Global Change Notification (GCN)

Product Family	Impact Plus 85 Ohm 37mm Mezzanine	10704714	
		GCN Number	
Series	170390	July 28, 2015

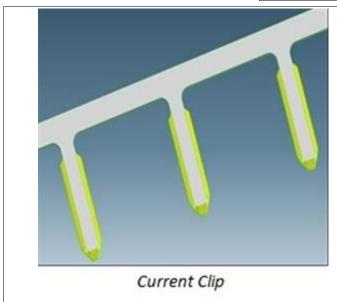
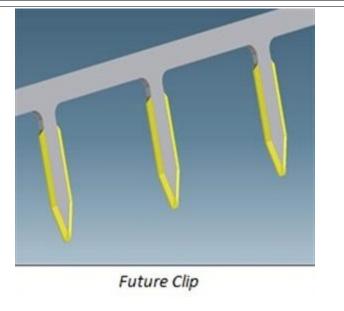
As part of our efforts for continuous improvement, Molex is implementing a running change on Impact Plus 85 Ohm 37mm Mezzanine. The changes will improve manufacturability as well as reduce the risk of debris by modifying the plus clip geometry slightly to improve the clip lead-in. This change has no impact on performance.
